STAFF RECOMMENDATION
1404 Gartland Avenue
March 15, 2017

Application: Partial demolition; New construction—addition; Setback determination
District: Lockeland Springs-East End Neighborhood Conservation Zoning Overlay
Council District: 06
Map and Parcel Number: 08309033500
Applicant: Jeff Joachim, Owner
Project Lead: Melissa Baldock, melissa.baldock@nashville.gov

Description of Project: Application is to demolish an existing extension and to construct a new rear addition. The addition requires a side setback determination. On its right/east side, the addition will sit four feet, six inches (4'6") from the side property line, six inches (6") less than the required five foot (5') side setback.

Figure 1. 1404 Gartland Avenue

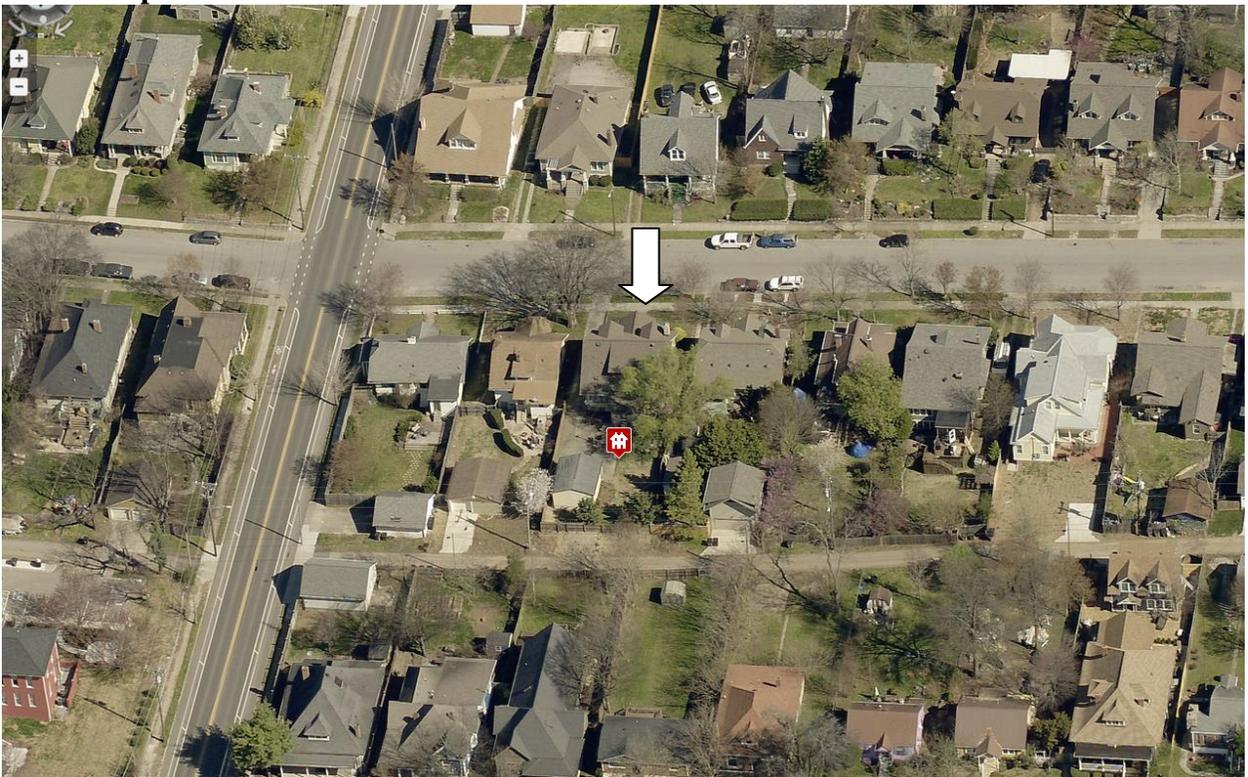
Background: 1404 Gartland Avenue is a c. 1937 stone bungalow that contributes to the historic character of the Lockeland Springs-East End Neighborhood Conservation Zoning Overlay (Figure 1).

Figure 2 (left) shows the extension that is to be demolished. Figure 3 (right) is the 1951 Sanborn Map, which does not show the footprint of the extension.

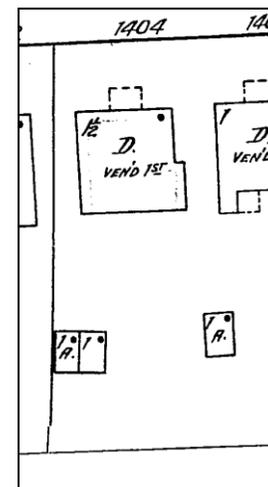
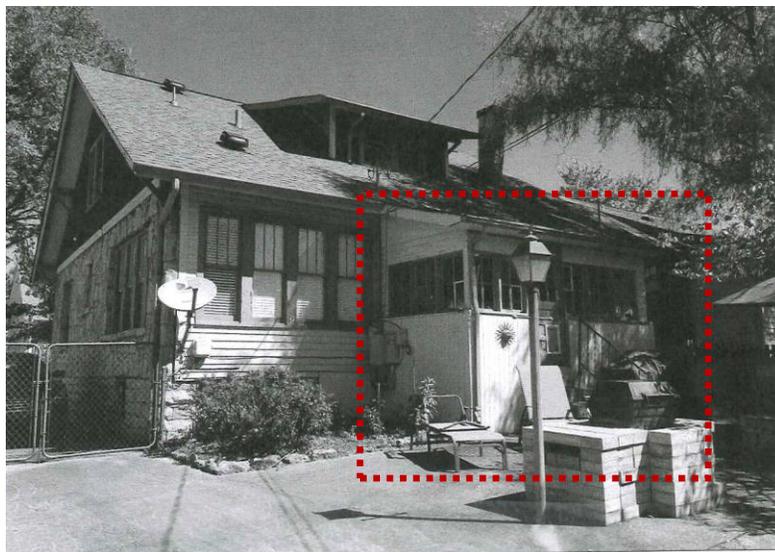
Demolition: The applicant intends to demolish a small, one-story rear extension (Figure 2). The date of construction for the rear extension is not noted, but it does not appear on the 1951 Sanborn Map (Figure 3). Staff finds that the extension's post 1951 date of construction, roof form, location, and design do not contribute to the historic character of 1404 Gartland Avenue, nor to the Lockeland Springs Neighborhood. Staff therefore finds that its demolition meets Section IV.B.2 for appropriate demolition and does not meet section IV.B.1 for inappropriate demolition.

PROPOSED REAR ADDITION

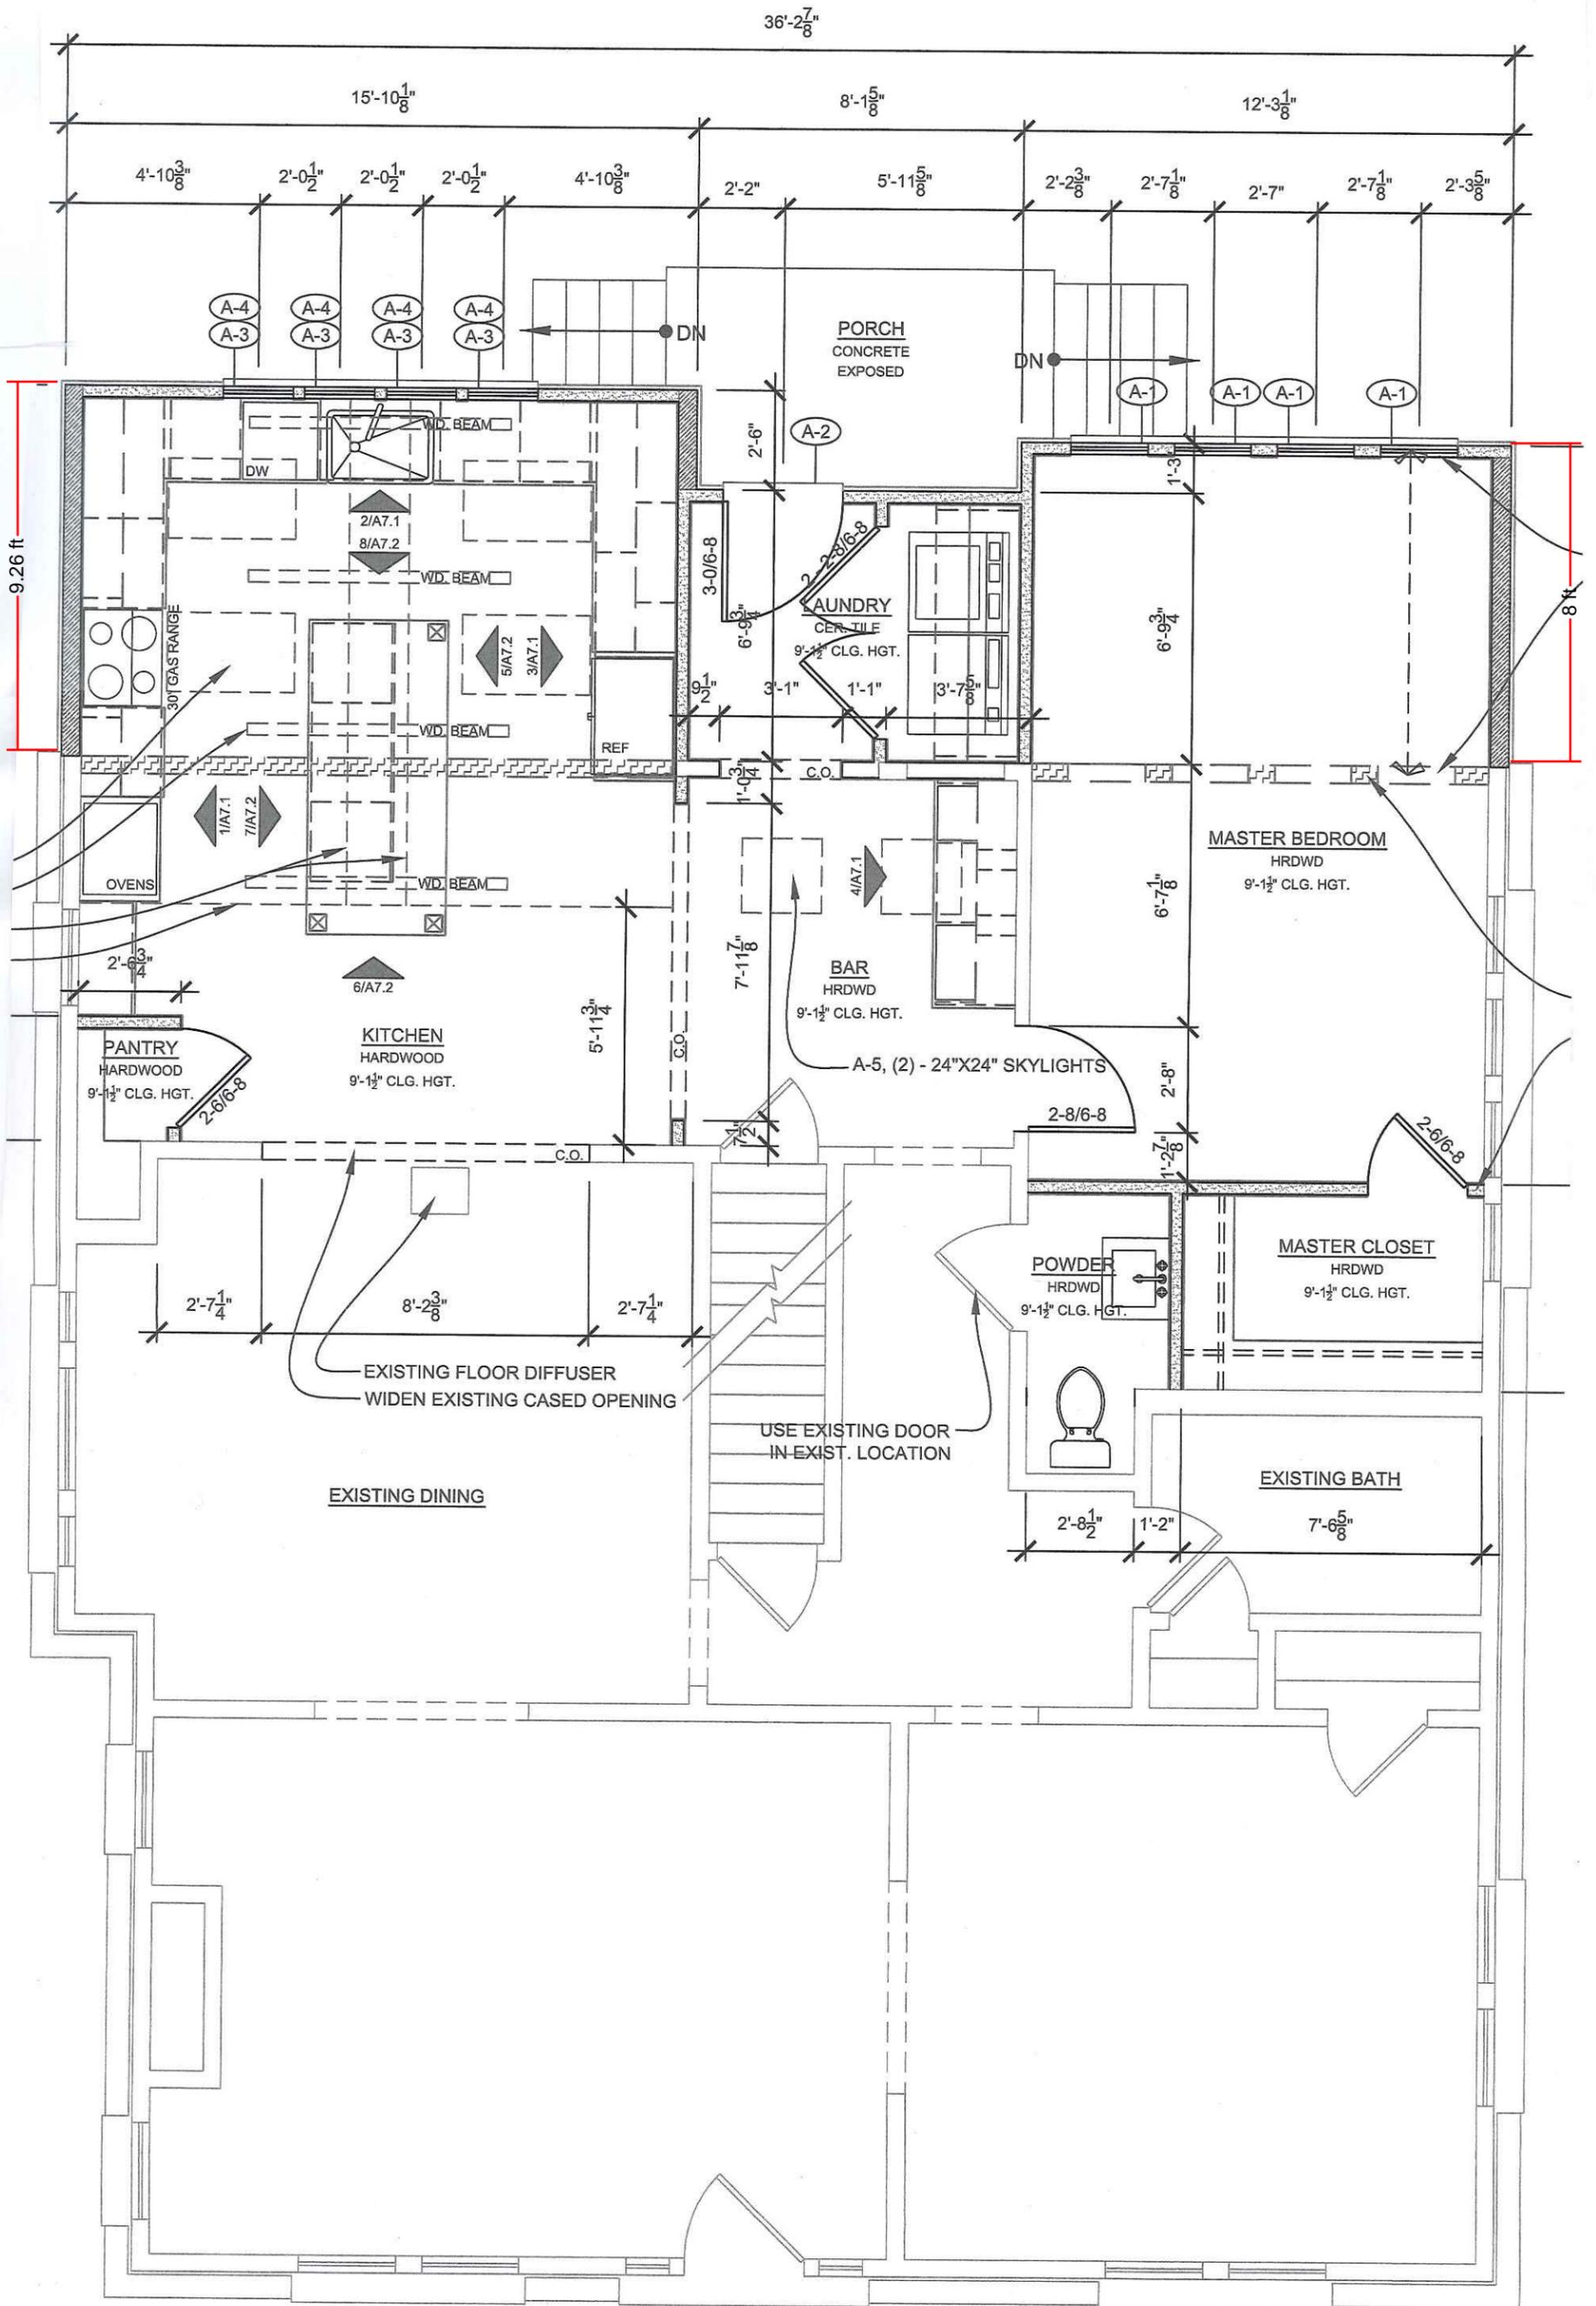
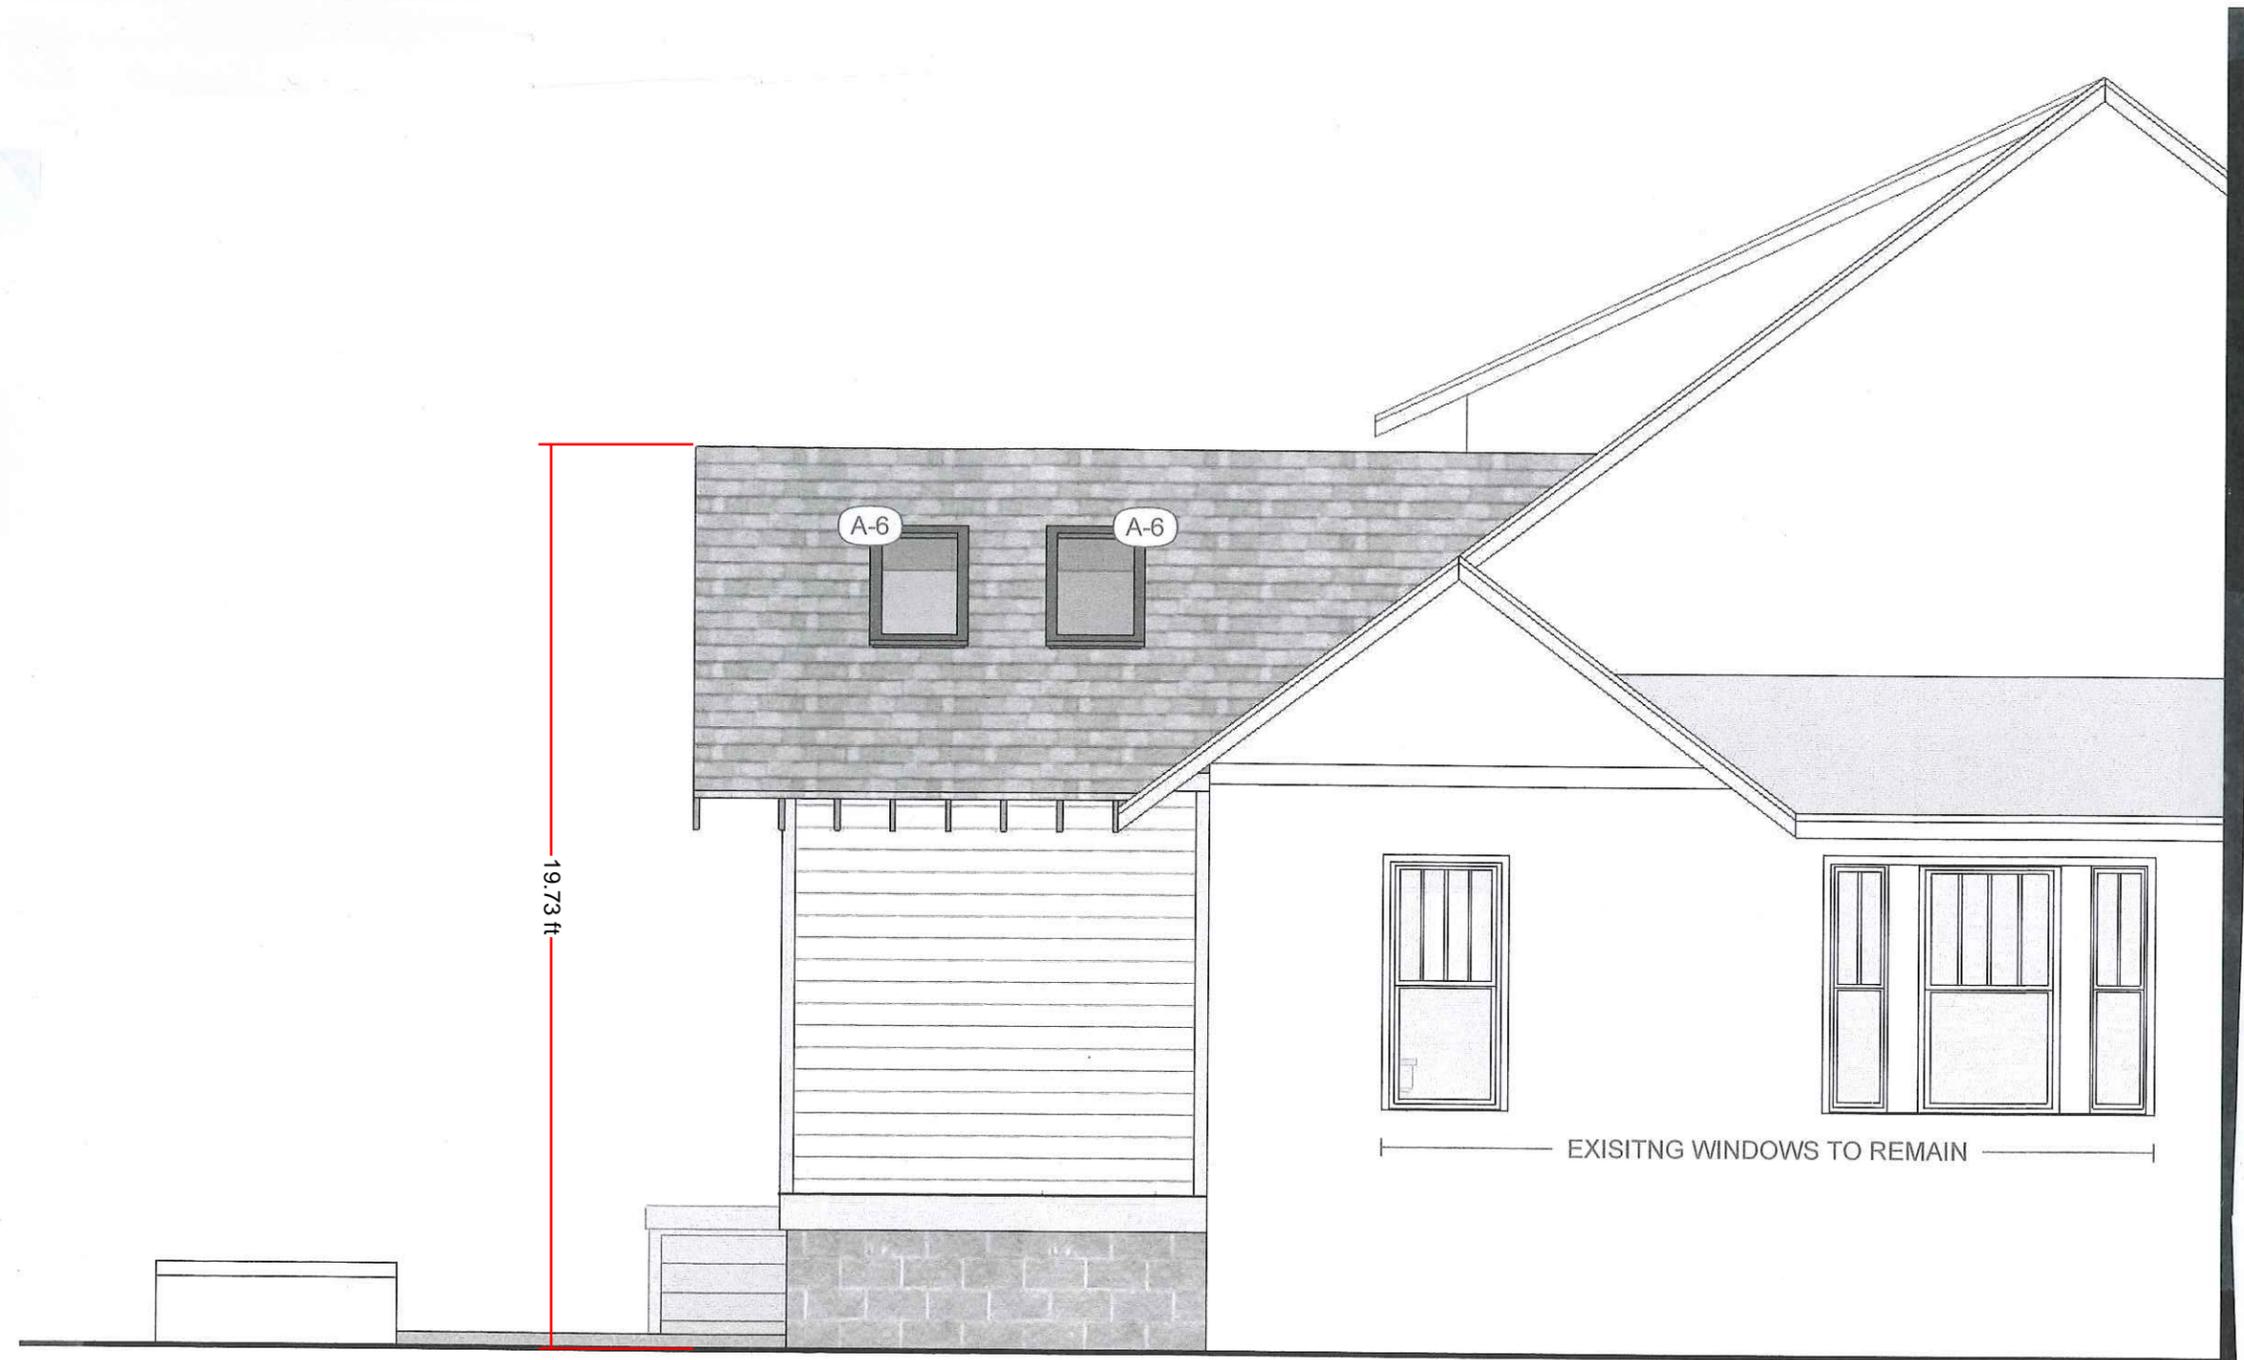
Height & Scale: The proposed addition is one-story in height. Its eave height and foundation heights will match those of the historic house. The addition will have a maximum ridge height of approximately nineteen feet, nine inches (19'9"), which is about eight feet (8') shorter than the ridge height of the historic house.

The addition will add approximately three hundred and eleven square feet (311 sq. ft.) of footprint to the historic house, which has a footprint of over fourteen hundred square feet (1,400 sq. ft.). The addition will inset six inches (6") from the rear walls. Although the Commission typically requires one-story additions like this one to step in one foot (1') from each of the rear corners, staff finds the six inch inset to be appropriate for two reasons. First, the addition is modest in depth and scale. It is only nine feet, three inches (9'3") deep on the left side and eight feet (8') deep on the right side. It is a true one-story addition that is several feet lower than the historic house. Second, there is a change in

Setback & Rhythm of Spacing: The proposed addition requires a side setback determination on the left side. The historic house is shifted on the lot so that it is just four feet (4’) from the right/east side property line. The addition will be set in six inches (6’’) from the back corner of the house, and will therefore be four feet, six inches (4’6’’) from the side property line. This is six inches (6’’) less than the required five foot (5’) side setback. Staff finds that the proposed side setback determination to be appropriate because the addition is no wider than the historic house, and is inset appropriately. Also, the addition has a modest depth of only nine feet (9’), and it is a mere six inches (6’’) less than what is typically required for a side setback. Staff therefore finds that the proposed addition and setback determination meets Sections II.B.3. and II.B.10. of the design guidelines.

Roof form: The addition will have two gabled elements, each with a slope of 9/12, that are connected with a shed roof. Staff finds the proposed roof form to be compatible with the historic house’s side gabled roof form, and finds that it meets Sections II.B.5. and II.B.10. of the design guidelines.

Proportion and Rhythm of Openings: No changes to the window and door openings on the existing house were indicated on the plans. The windows on the proposed addition are all generally twice as tall as they are wide, thereby meeting the historic proportions of openings. There are no large expanses of wall space without a window or door opening. Staff finds the project’s proportion and rhythm of openings meet Section II.B.7. and II.B.10. of the design guidelines.

Appurtenances & Utilities: No changes to the site’s appurtenances were indicated on the drawings. The HVAC units will need to be relocated for the construction of the addition. Staff recommends that the HVAC be located on the rear façade, or on a side façade beyond the midpoint of the house in order to meet Section II.B.9. of the design guidelines.

1. Staff approve the final details, dimensions and materials of windows and doors prior to purchase and installation;
2. Staff approve the roof shingle color; and
3. The HVAC be located behind the house or on either side, beyond the mid-point of the house.
